SUBJECT: Docket No. 50-244, R. E. Ginna Nuclear Power Plant

Attachment B

Response to Question 6 on Mixed Oxide Fuel  
(Proprietary)

Figure 1. Comparison of Densification Data for  $UO_2$ -3%  $PuO_2$  with  $UO_2$   
Both Fabricated under Similar Conditions to a Density of  
Approximately 91% T.D.

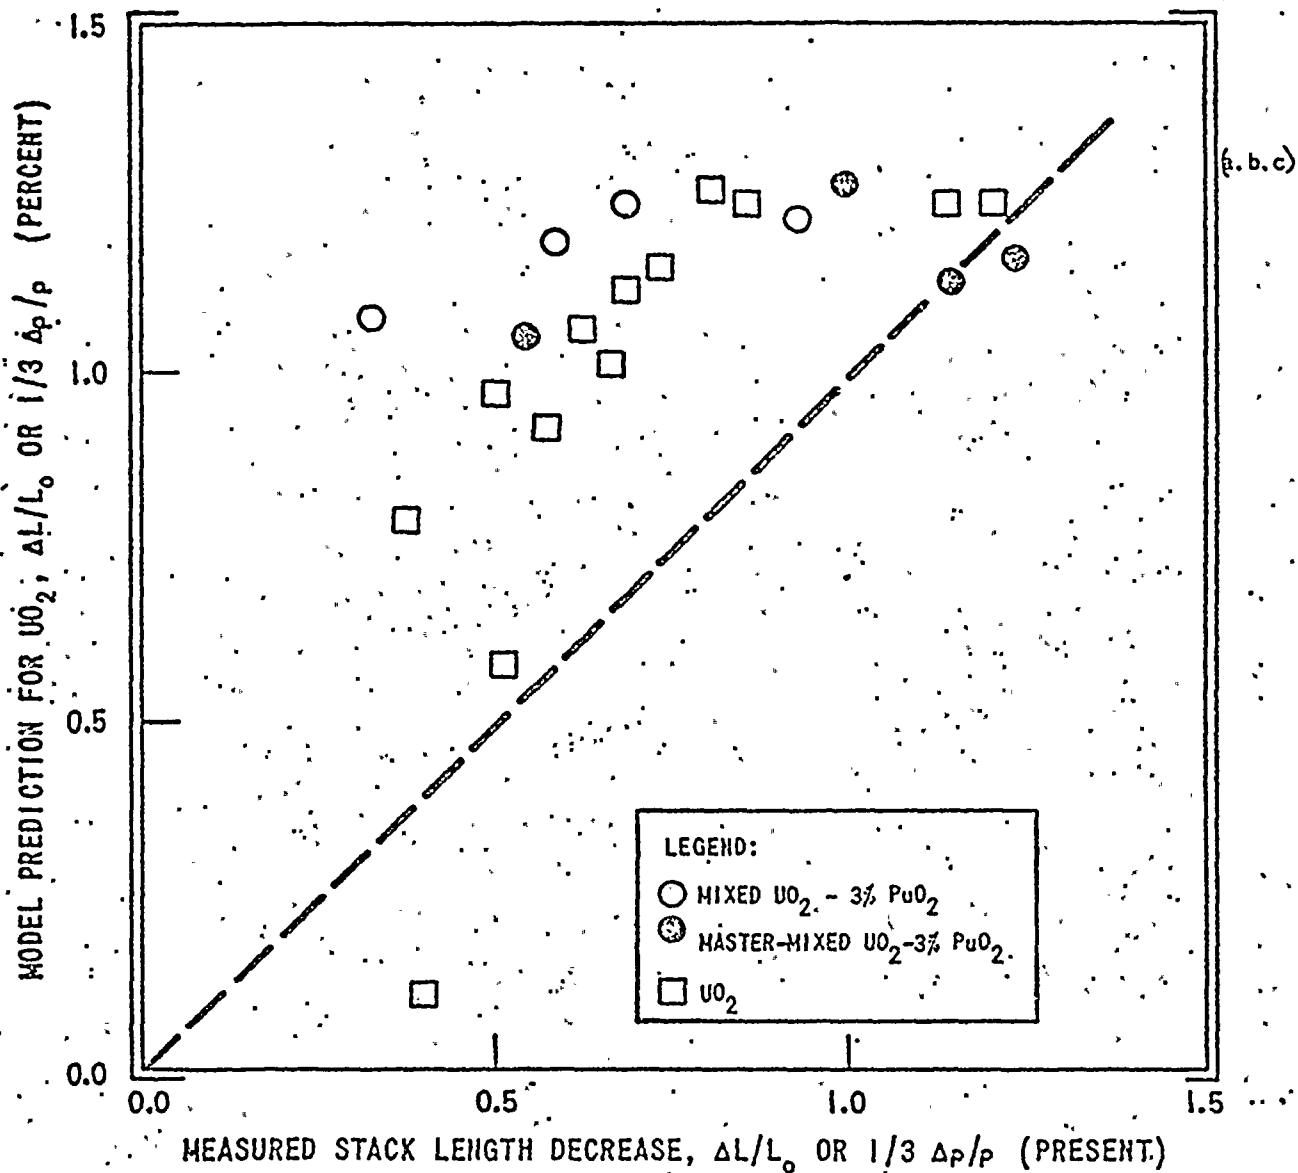
6. The staff SER on Mixed Oxide Fuel states that use of  $UO_2$  densification models for MOX should be verified.(1) Since it appears that this assumption was used for the MOX fuel for Ginna, please verify this assumption. Does the predicted amount of densification satisfy Reg. Guide 1.126.

experience with densification of  $MO_x$  fuel operated in a commercial power reactor is compared with predicted values in Figure 1 which is taken from WCAP-8349-P. The Figure also contains data for the performance of a  $UO_2$  fuel with similar fabrication characteristics for direct comparison. Figure 1 contains data for both mechanically mixed and "mastermixed" fuel. Mastermixed fuel is prepared by co-precipitating  $UO_2$  and  $PuO_2$ , then mixing the Co-precipitated material with  $UO_2$ .

The  $UO_2$  model is a best estimate model and hence there should be as many points with densification under predicted as overpredicted. This is obviously not the case for either the  $UO_2$  or  $MO_x$  fuel with the densification being generally overpredicted. Significantly, the prediction of the model was noticeably more conservative for the  $MO_x$  fuel than for the  $UO_2$  with similar processing history. As shown in Figure 1, the prediction for master mixed  $MO_x$  was less conservative than for mechanically mixed  $MO_x$ . This is as expected and further illustrates the lower densification expected from fuel with inhomogenously distributed fission events.
